Rampion 2 Offshore Windfarm – EN010117
Interested Party Reference – 20045298

Response from the South Downs National Park Authority to the Examining Authority's Action Points from Issue Specific Hearing 2 (ISH2)

Appendix D – SDNPA comments on other Deadline 3 Submissions

Fig. 01 Elevation change along Michelgrove Lane and Tolmare Farm construction route

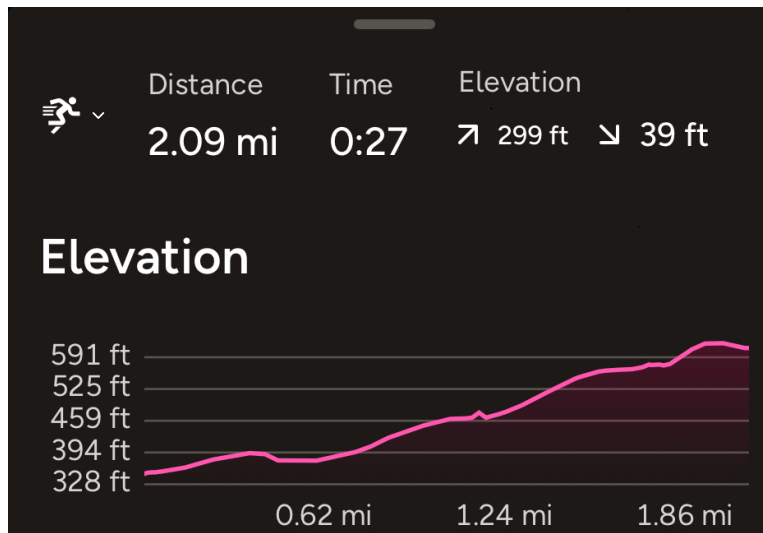
- 4.1 The SDNPA's comments on this document relate specifically to Appendix D: Technical Note – Construction Accesses A-26, A-28, A-61 and A-64 Traffic Management Strategies and focus on accesses A-26 and A-28 at Michelgrove Lane and Tolmare Farm.
- 4.2 The SDNPA is concerned that the tracking provided for HGVs at A-26 demonstrates it is not possible to turn left from Michelgrove Lane without occupying the southbound lane. Further consideration should be given to whether additional management controls are required.
- 4.3 It is also noted that the cable-drum HGV will not be able to complete a left-turn movement from A-28. We are concerned that further works will be required to enable this movement. Clarification should be provided as to what these works will entail.

4.4 The proposed construction route to serve the majority of the construction traffic within the SDNP would comprise an approximately 10km route through what is largely open downland. It is not clear whether the effects of this have been fully assessed in respect of the National Park Purposes and the Special Qualities. As this route is, for HGV movements, largely a one-way route, this has the potential to have a sustained impact across the construction period. Furthermore, as demonstrated from the figure below, there is a noticeable increase in elevation across the route. This is similar to the gradient of the Lickey Incline in Birmingham, which is the steepest gradient on a British standard gauge railway. Further clarity that additional works will not be required to enable HGVs to manoeuvre over the 'bump' at the c.1.24 mile point is requested (see fig. 01 below).
